**ADDENDUM NO. 2  
PROJECT BI-CTC-455**

Date: April 23, 2015  
Renovations and Addition to Lafayette Hall  
Housatonic Community College  
Bridgeport, CT

Renovations and New Addition to Lafayette Hall  
Housatonic Community College  
Bridgeport, Connecticut

This addendum is issued to show corrections, revisions and clarifications to the BID Documents Submission for the *Renovations and New Addition to Lafayette Hall at Housatonic Community College*, dated March 6, 2015.

**AD2-S4**

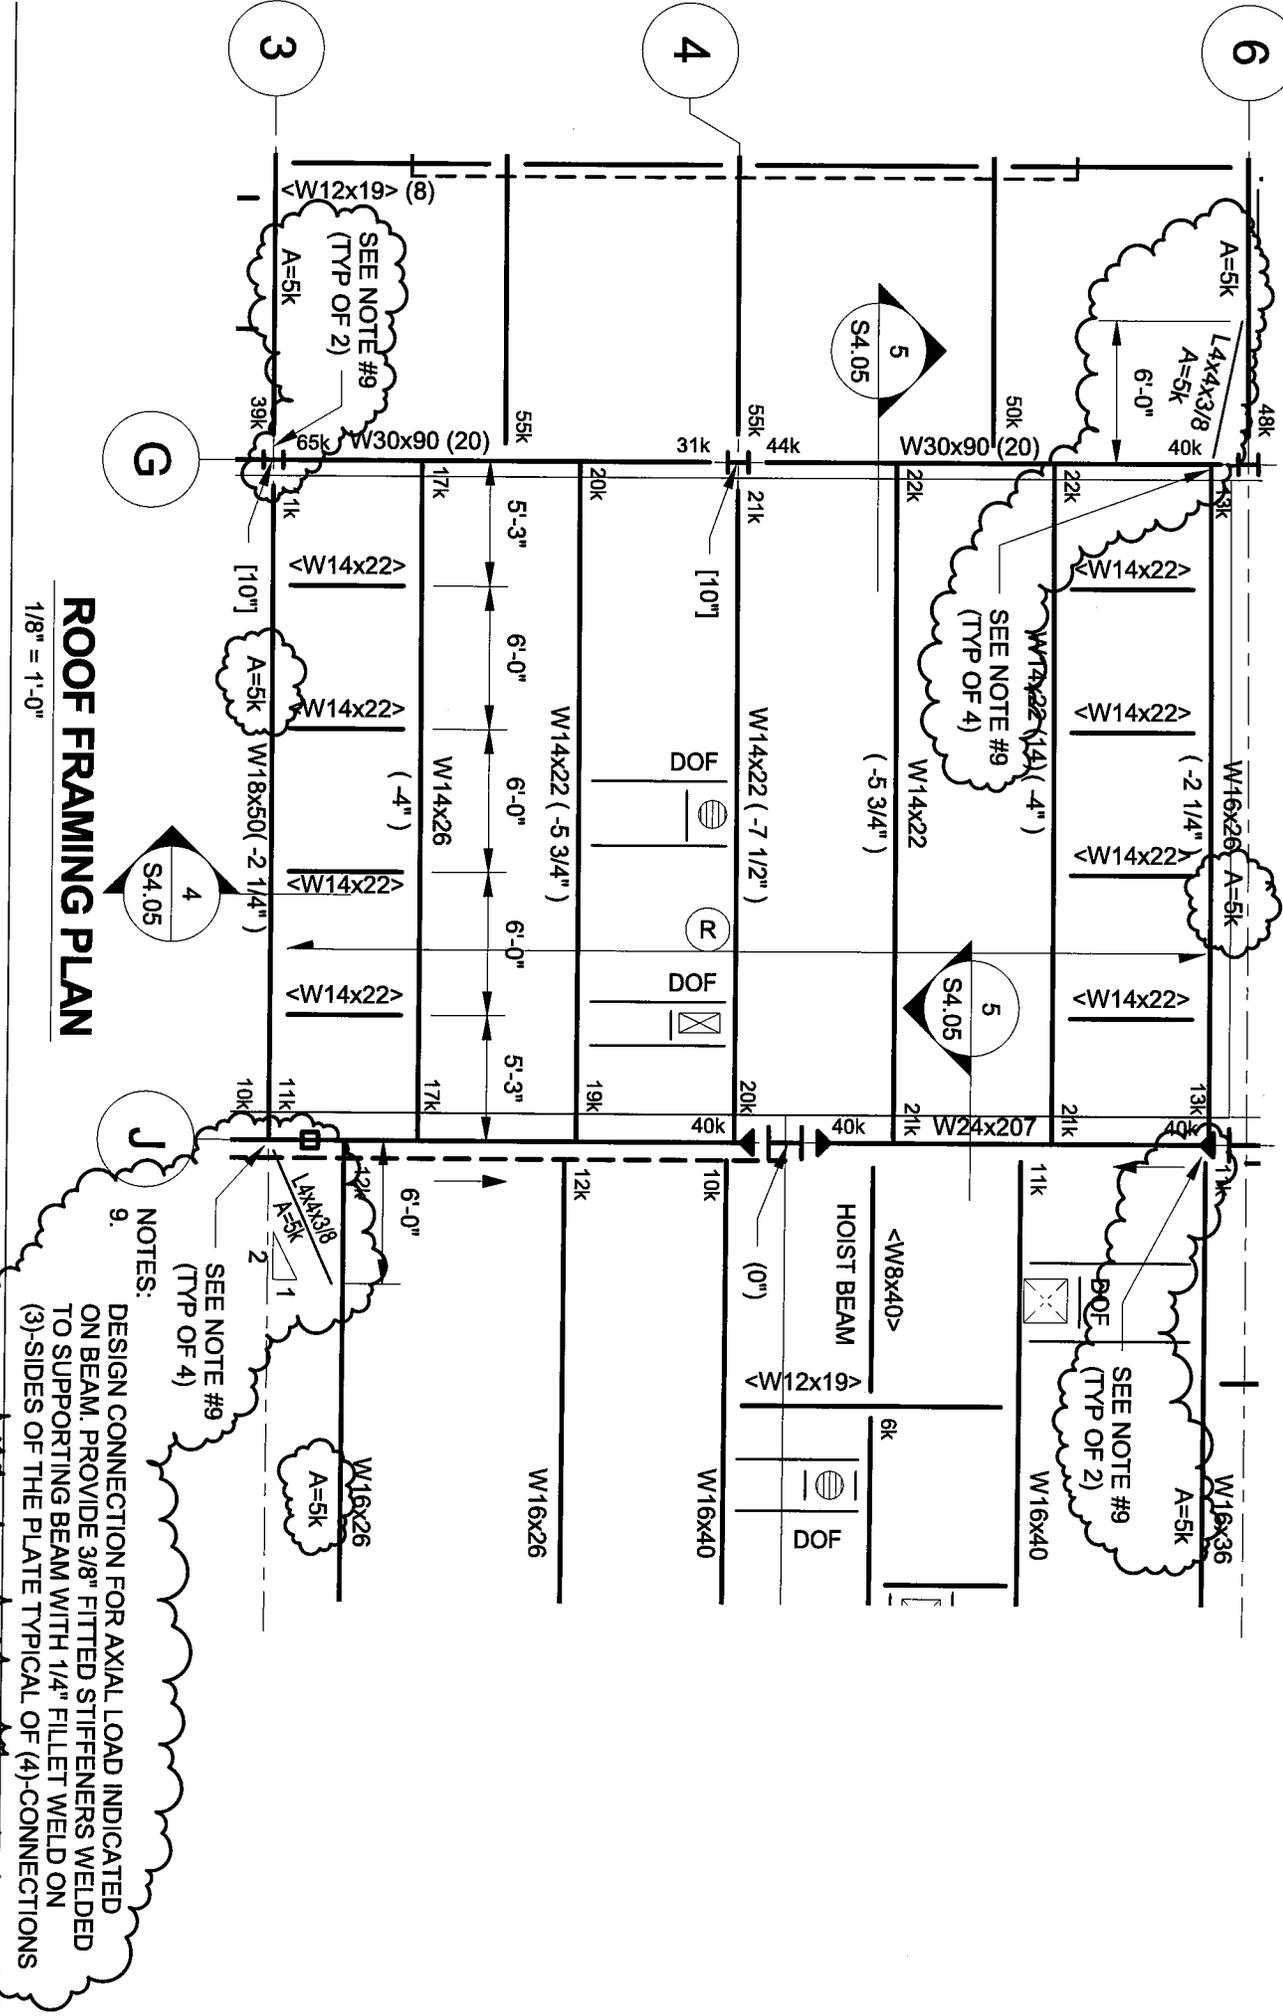
- Roof Framing Plan: **ADD** note #9 and axial load to beam and connections as indicated on sketch AD2-S4.

NOTES:  
 9. DESIGN CONNECTION FOR AXIAL LOAD INDICATED ON BEAM. PROVIDE 3/8" FITTED STIFFENERS WELDED TO SUPPORTING BEAM WITH 1/4" FILLET WELD ON (3)-SIDES OF THE PLATE TYPICAL OF (4)-CONNECTIONS

AD2-S6

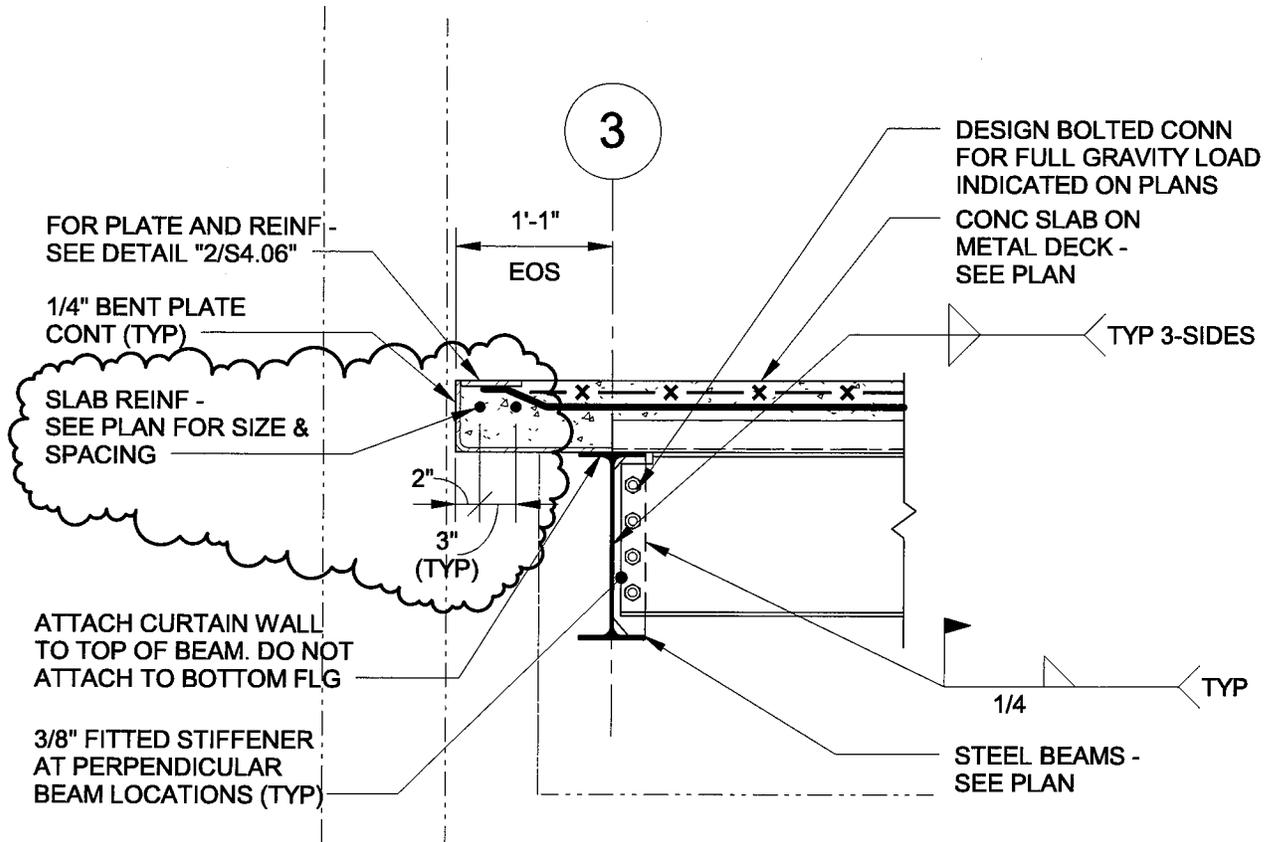
- Detail 15: **ADD** slab reinforcing as indicated on sketch AD2-S6.

**AD2-S7**

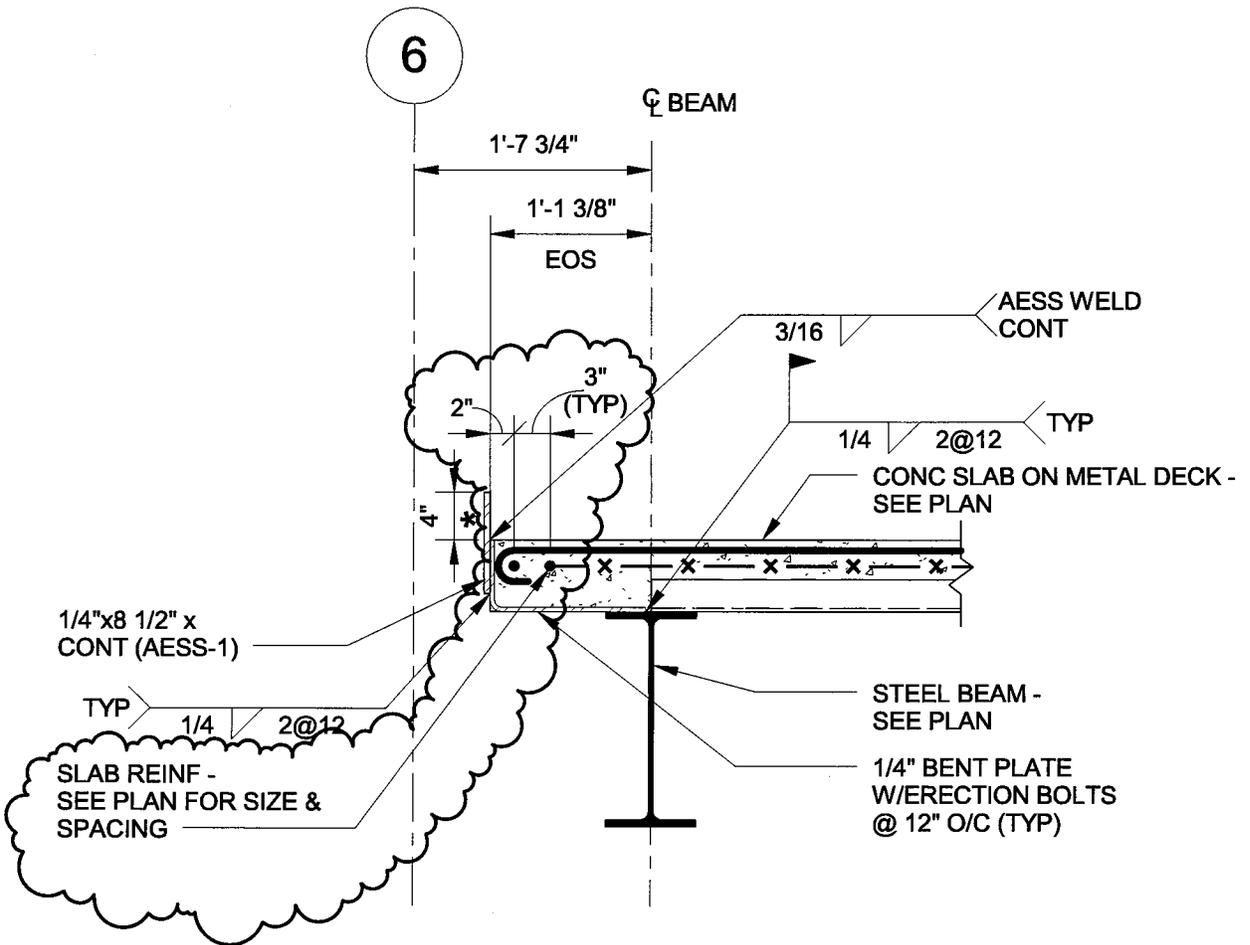
- Detail 4: **ADD** slab reinforcing as indicated on sketch AD2-S7.
